ALERT SERVICE BULLETIN

SUBJECT: ELECTRICAL POWER - DC electrical power

Replacement of a power cable belonging to very cold weather starting optional equipment

Corresponds to modification 074838.

Figure 1

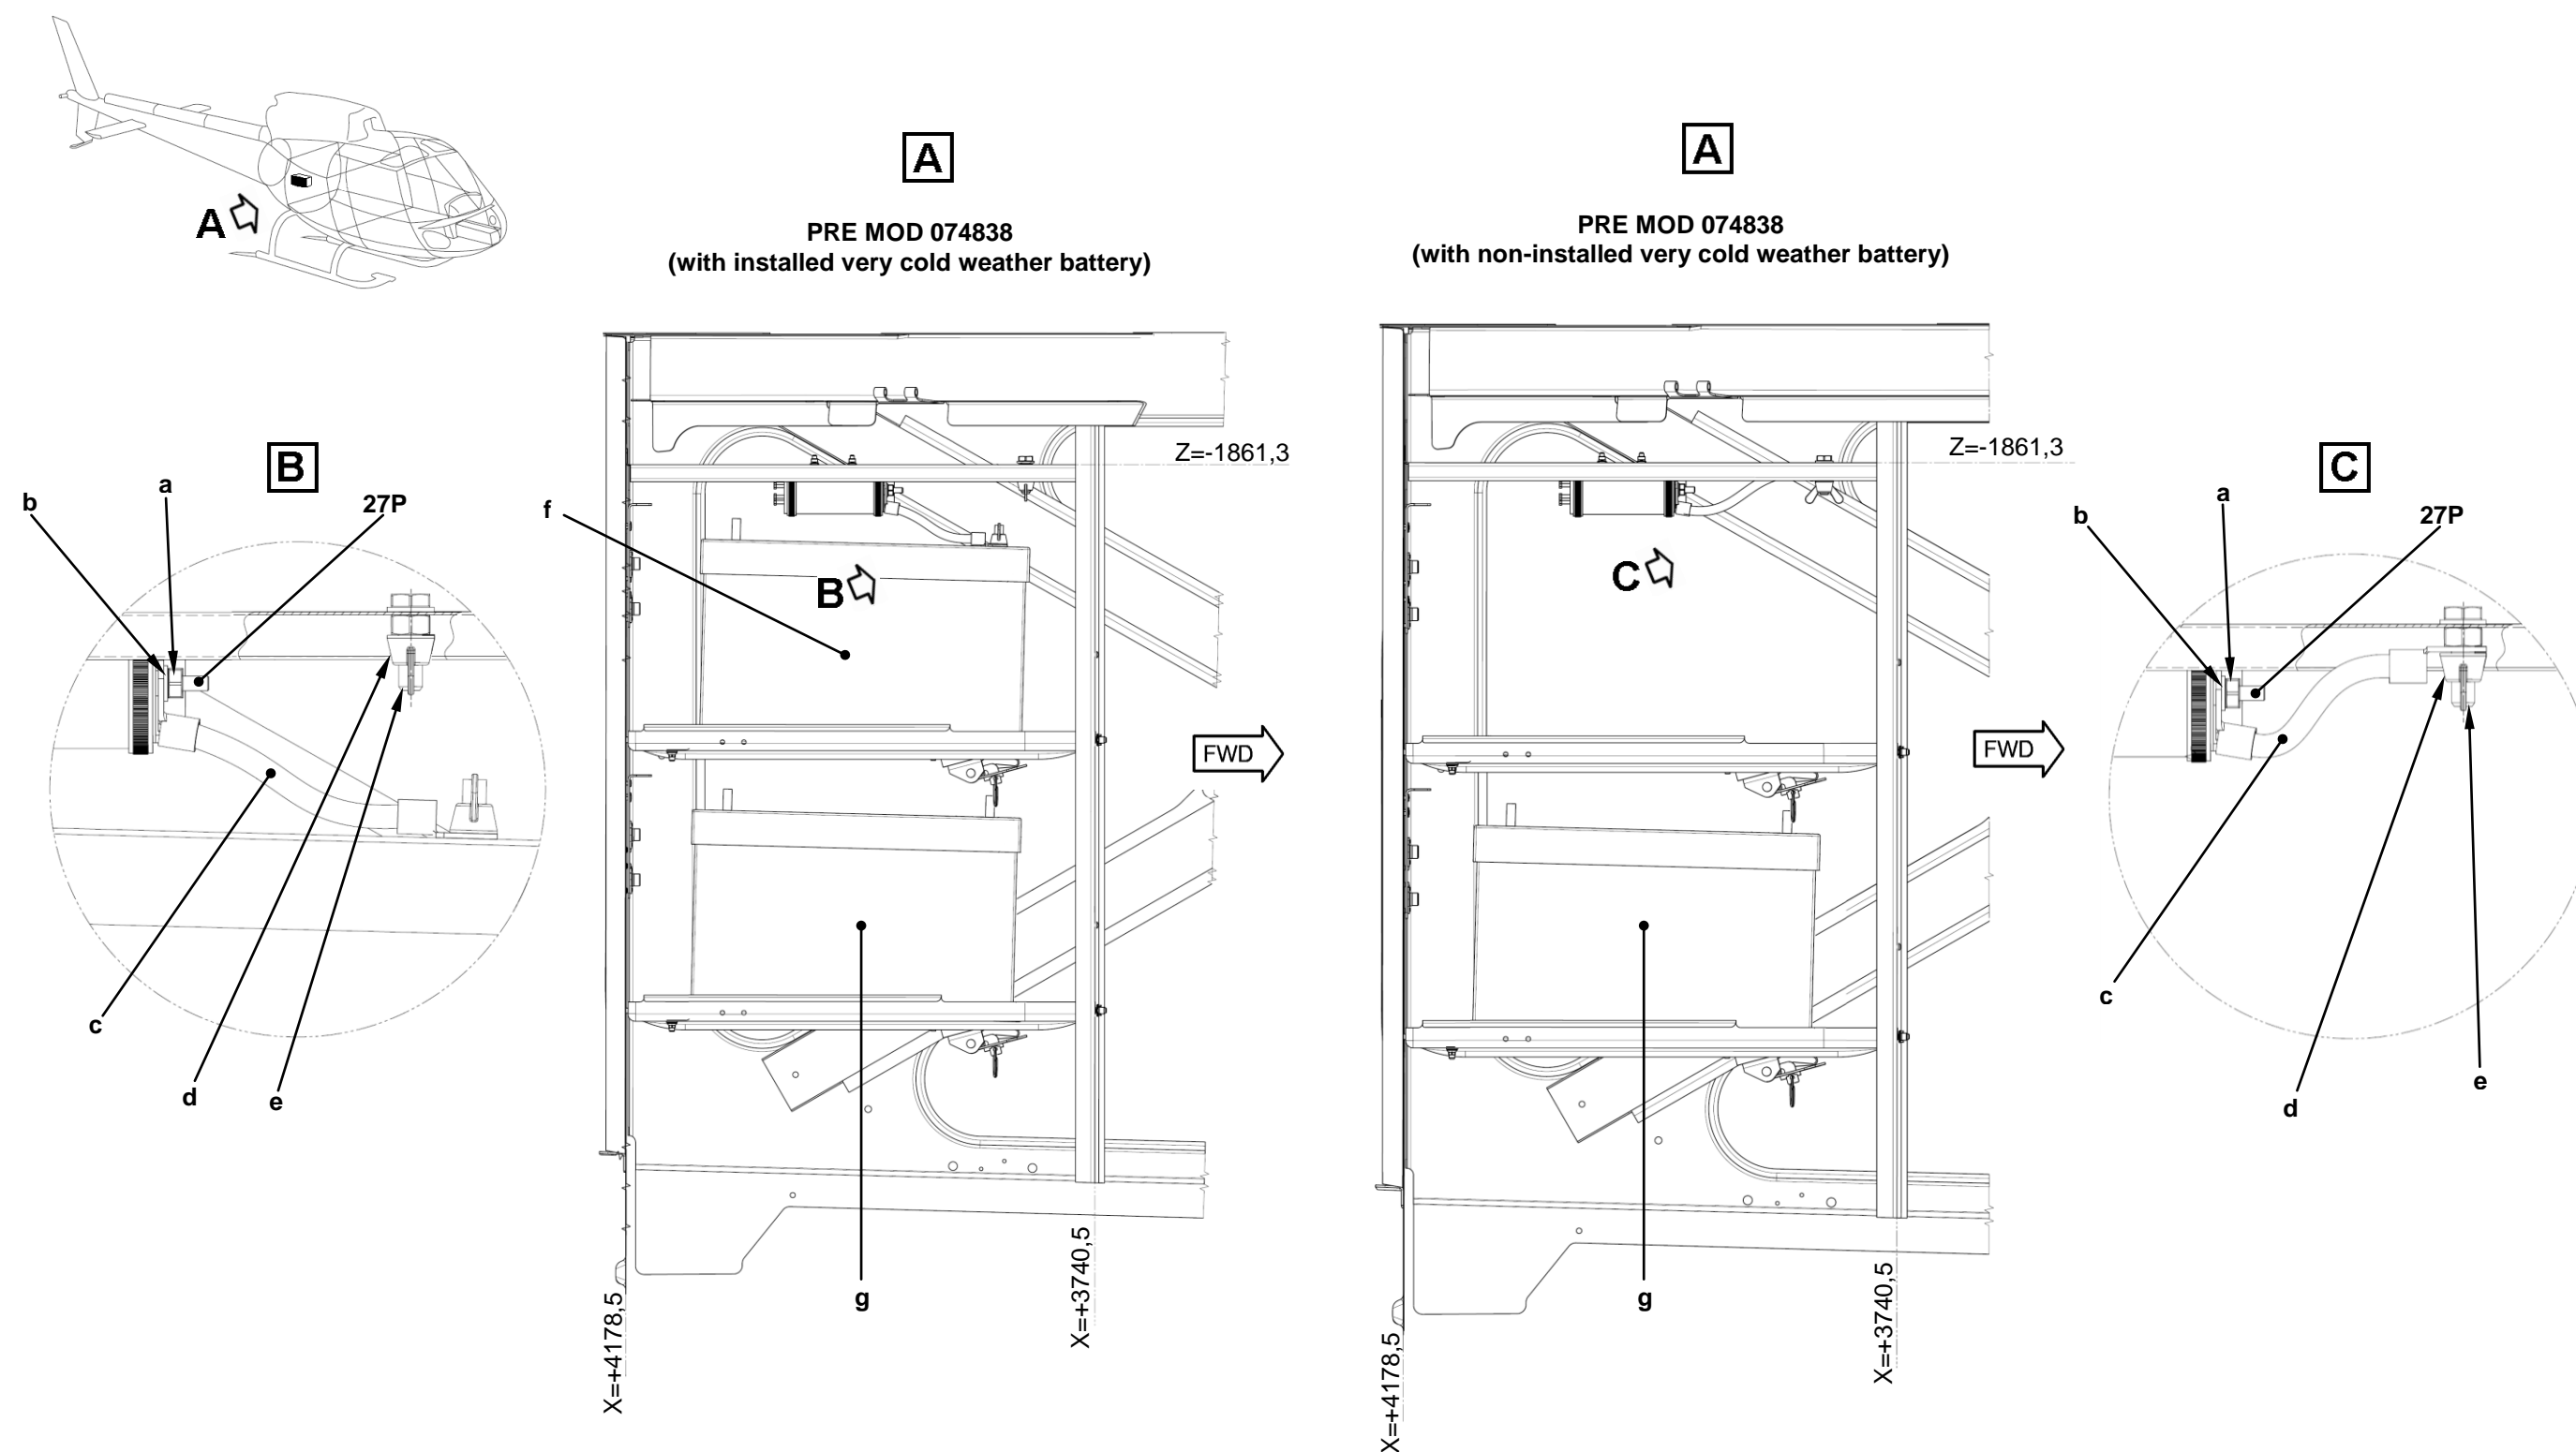
3.B.2. Improvement of the very cold weather starting installation (Figures 1 and 2)

3.B.2.a. Installed very cold weather battery (Detail B)

- Remove battery (g) and very cold weather battery (f) as per AMM Task 24-33-00, 4-1 or MET Task 24-30-00-401.
- Remove and retain nut (a) and washer (b).

- Disconnect "+BATT" cable (c) from terminal "27P" and scrap it.
- Remove and retain butterfly nut (d) from resting point assembly (e).
- Remove and retain resting point assembly (e).

- Install resting point assembly (e) by means of the new polyamide washer (3) and the new polyamide nut (2).
- Tighten polyamide nuts to standard torque.

- Install butterfly nut (d) on resting point assembly (e).
- Connect the new "+BATT" cable (1) to terminal "27P" by means of washer (b) and nut (a).
- Tighten nut (a) as per MTC Work Card 20.80.20.605.

3.B.2.b. Non-installed very cold weather battery (Detail C)

- Remove very cold weather battery (g) as per AMM Task 24-33-00, 4-1 or MET Task 24-30-00-401.
- Remove and retain butterfly nut (d) from resting point assembly (e).

- Remove and retain nut (a) and washer (b).
- Disconnect "+BATT" cable (c) from terminal "27P" and scrap it.
- Remove and retain resting point assembly (e).

- Install resting point assembly (e) by means of the new polyamide washer (3) and the new polyamide nut (2).
- Tighten polyamide nuts to standard torque.

- Connect the new "+BATT" cable (1) to terminal "27P" by means of washer (b) and nut (a).
- Connect the new "+BATT" cable (1) to resting point assembly (e) by means of butterfly nut (d).

Figure 2

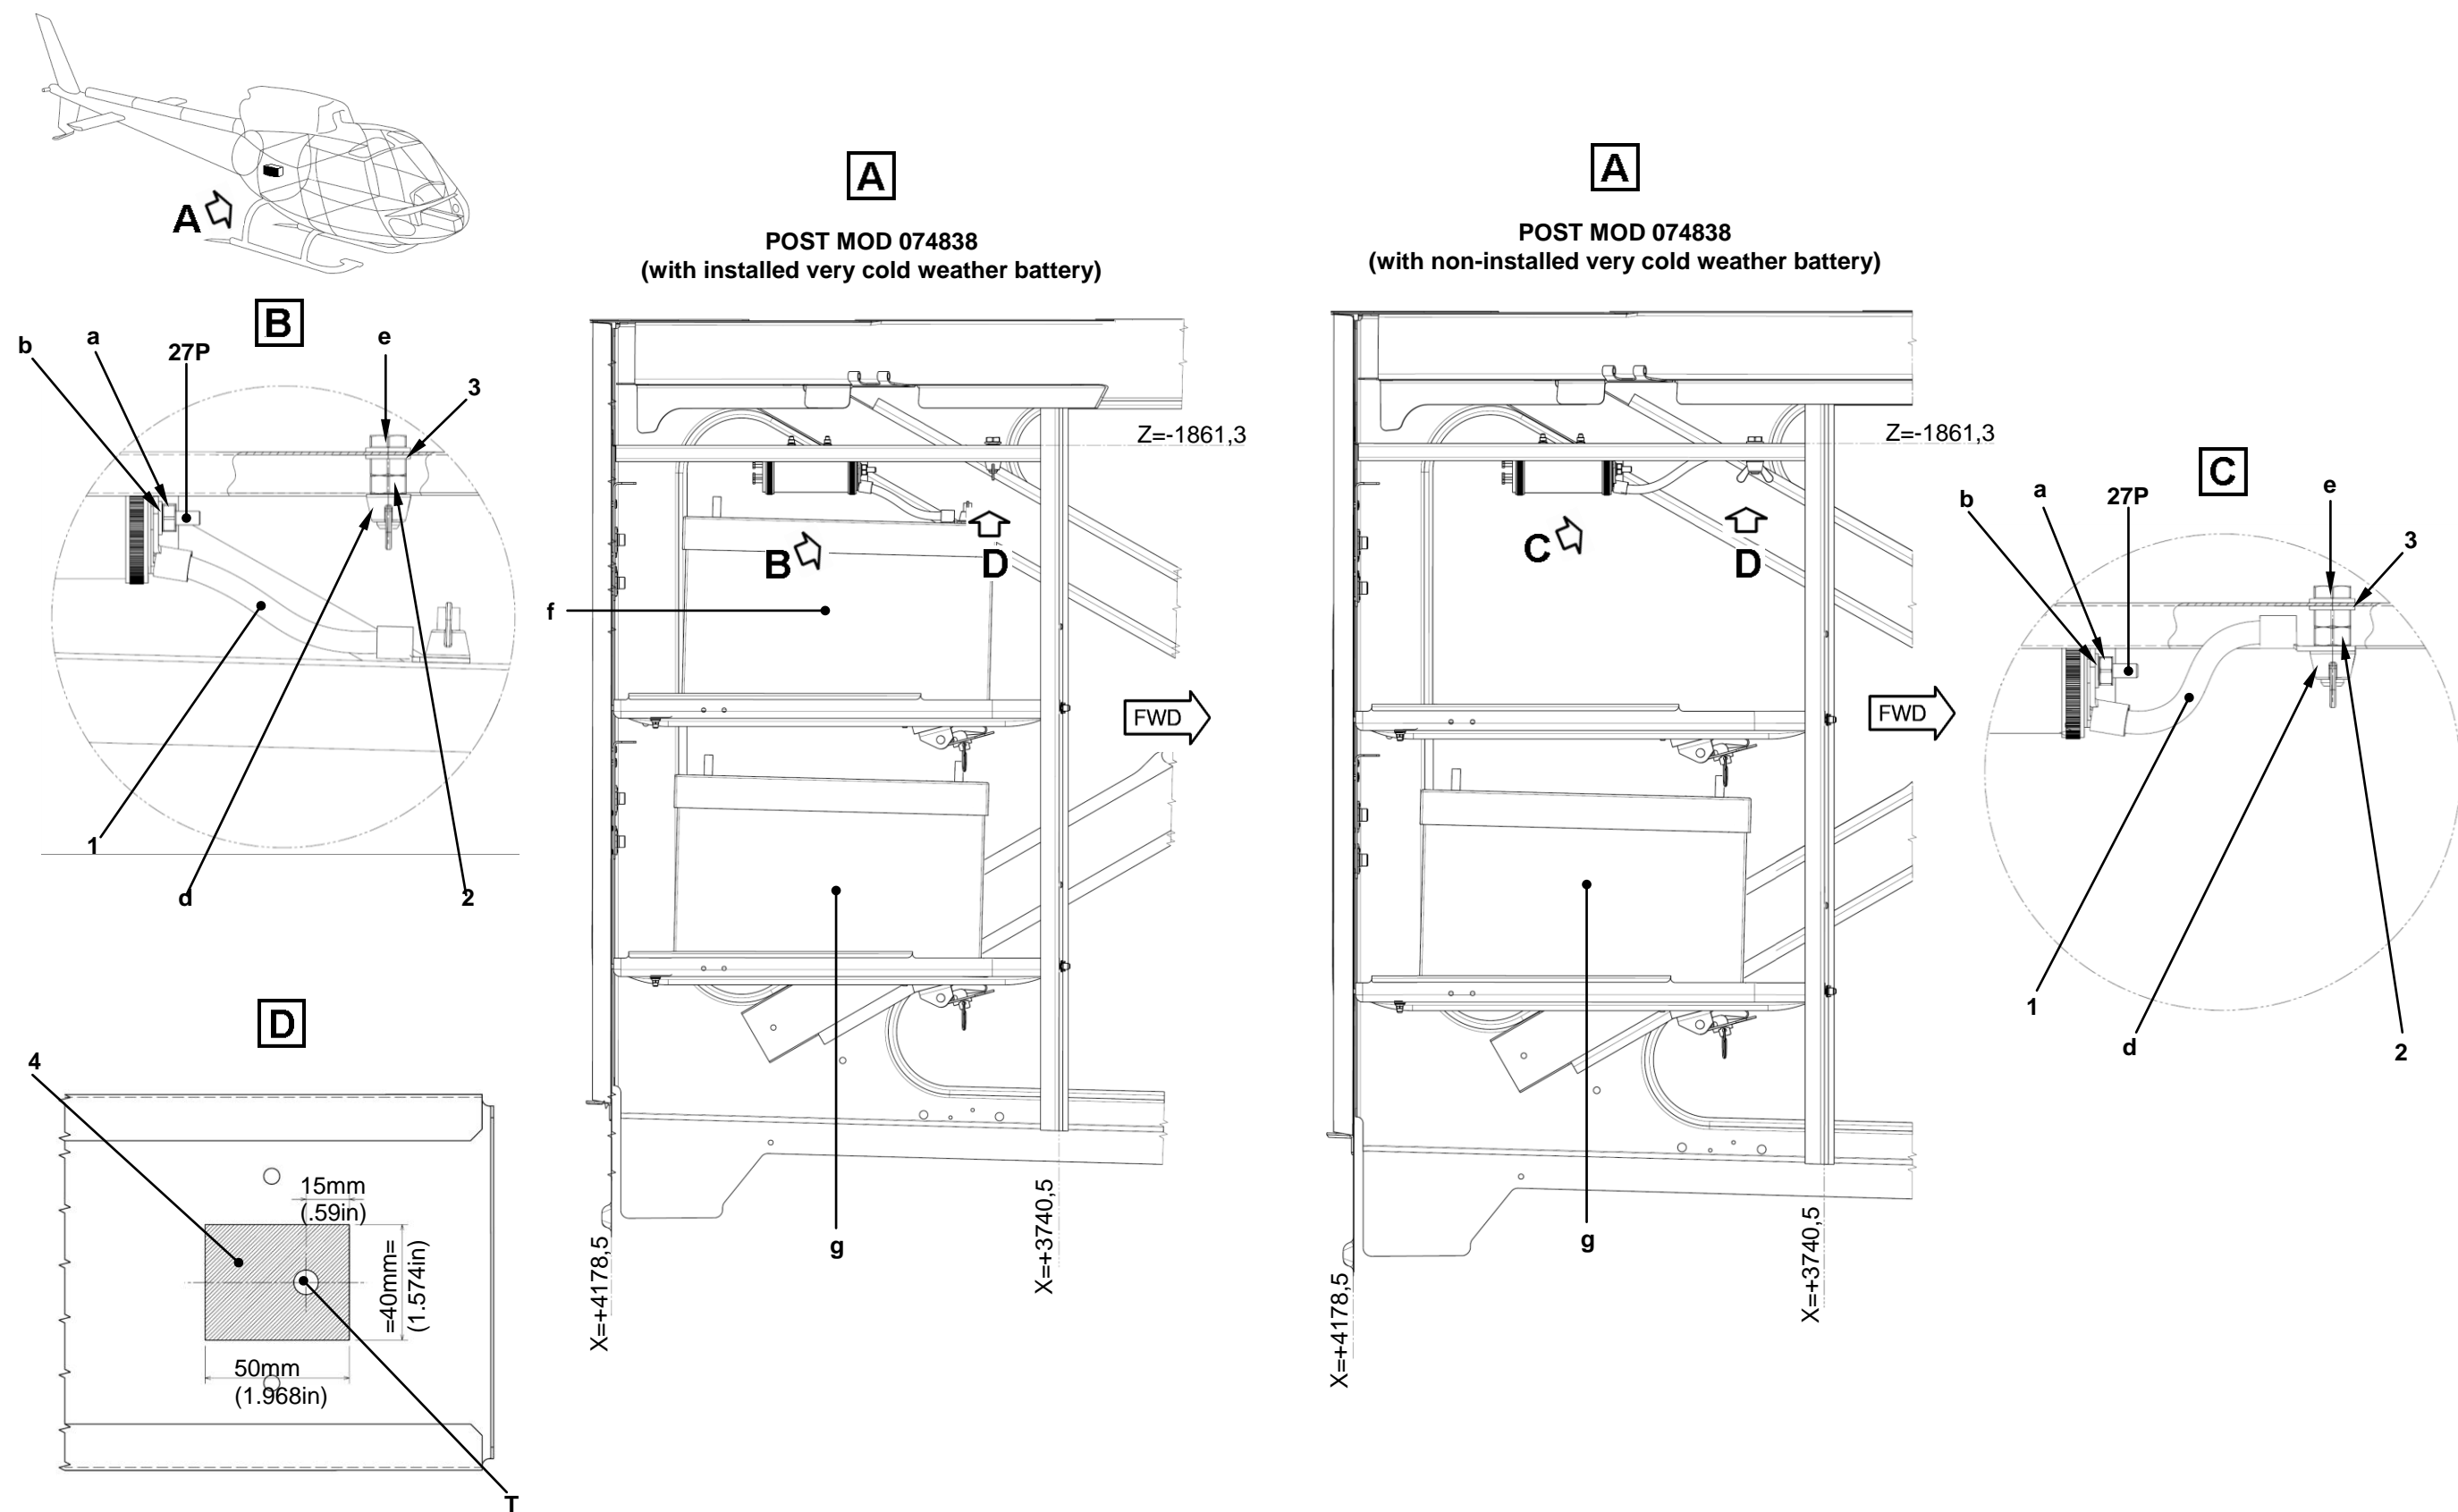
- Clean the bonding surface of teflon tape (4) on the structure as per MTC Work Card 20.04.01.102 and as per Figure 2 Detail D.
- Position and bond teflon tape (4) onto T hole of resting point assembly (e) as per Figure 2 Detail D.

- Clean the bonding surface of teflon tape (4) on the structure as per MTC Work Card 20.04.01.102 and as per Figure 2 Detail D.
- Position and bond teflon tape (4) onto T hole of resting point assembly (e) as per Figure 2 Detail D.
